APPENDIX F – CGS Response to ECCC Comments on 2014 WL Application

Taloyoak Water Licence: 3BM-TAL 0813

RE: Technical Comments on 3BM-TAL 0813 – Type “B” Municipal Water Licence, Taloyoak

Explanation and respond to EPOD Letter dated January 06, 2014

Monitoring Stations of sewage and solid waste sample collection

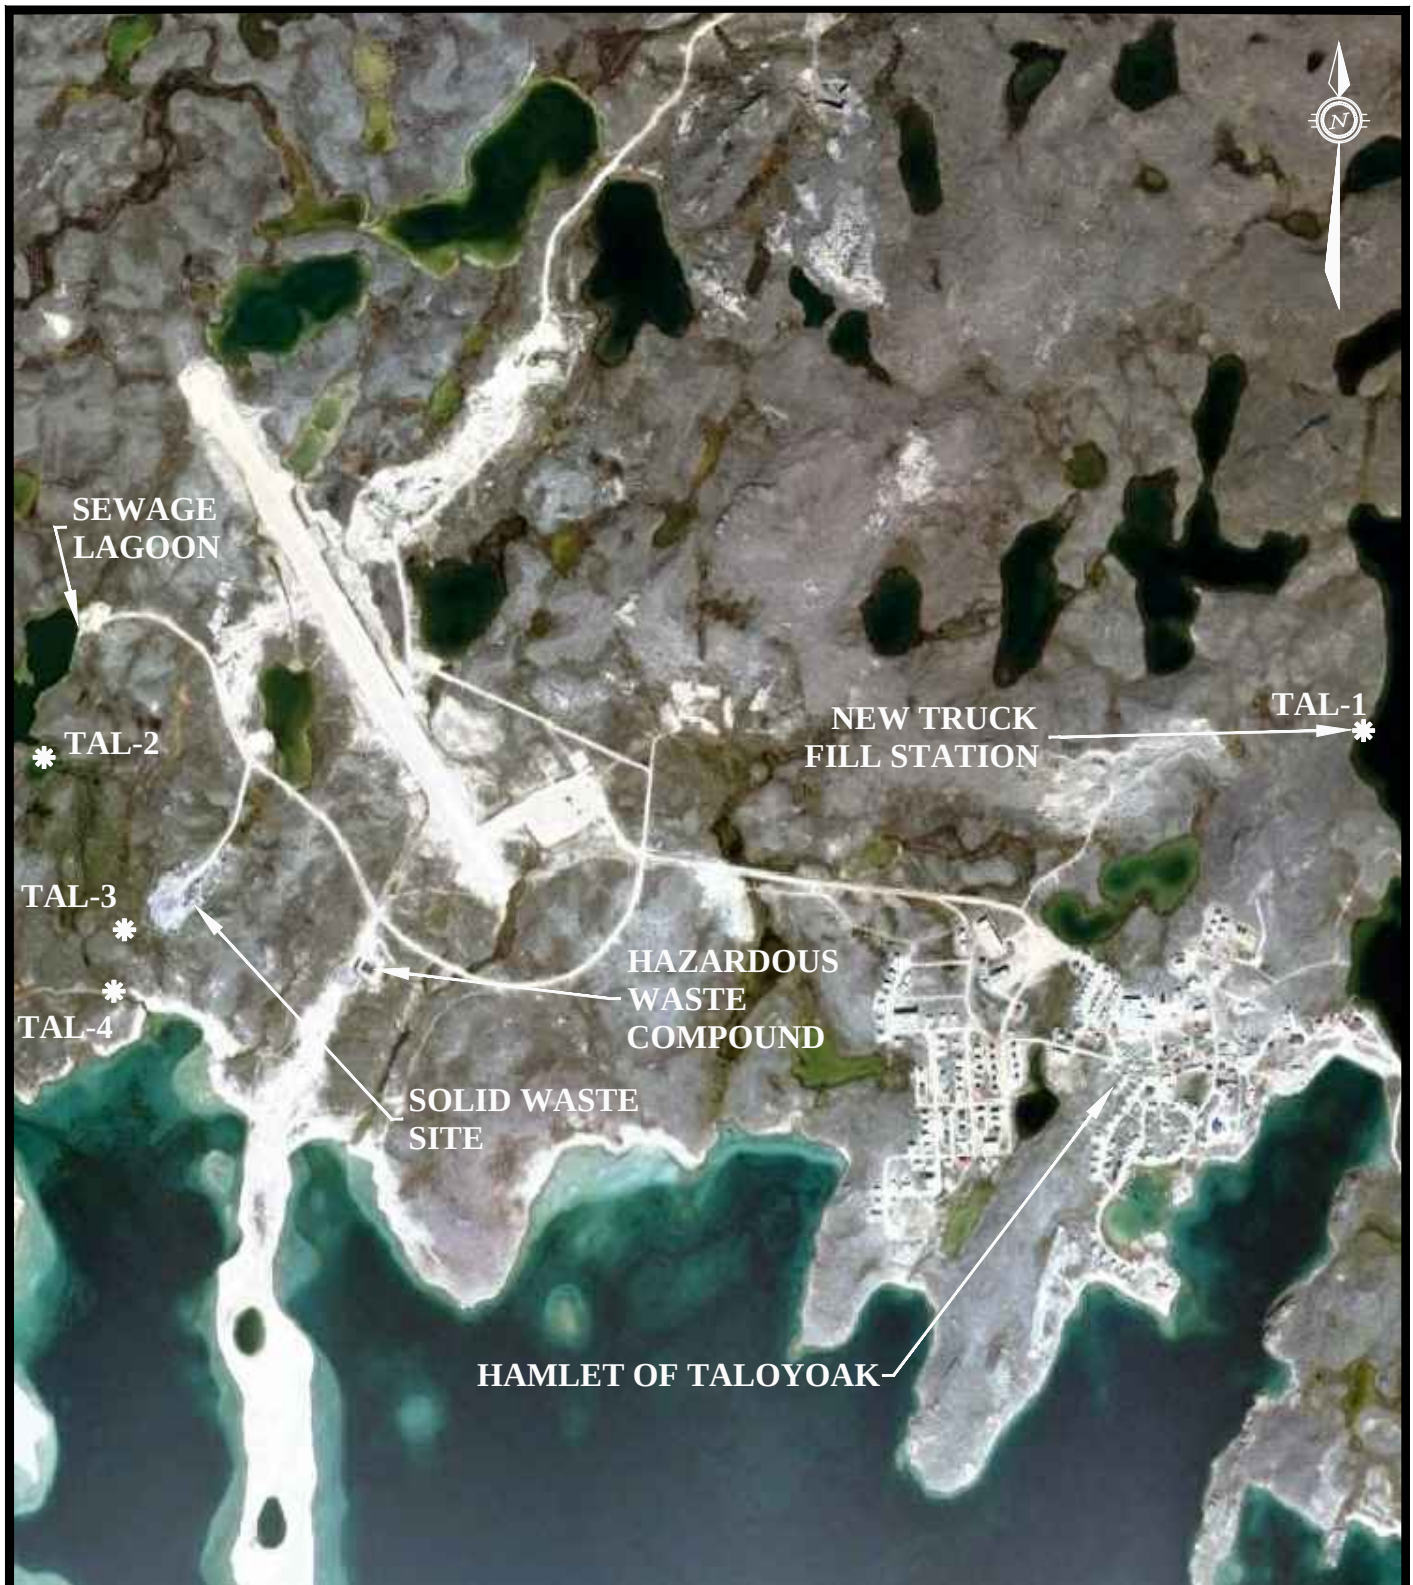
5. Monitoring Station TAL-5 for spill and contaminated storage retention:

EC notes that a new monitoring station, located at sampling station TAL-5 (hazardous storage cell retention water) will be sampled only when decanting is required.

Monitoring station TAL-3 established in sump area outside the solid waste facility (see Pic -3), runoff stores there before merging onto wetland (only when overflow). Sample results from TAL-3 met minimum standard parameters for PH, TSS, metals and remains within the lower value of MAC limit. Amendment Licence will re-establish those parameters based on standards and facility specific.

Water sample only be taken when it needs decanting to ensure contamination parameters level. So, far it doesn't require since no decanting happened.
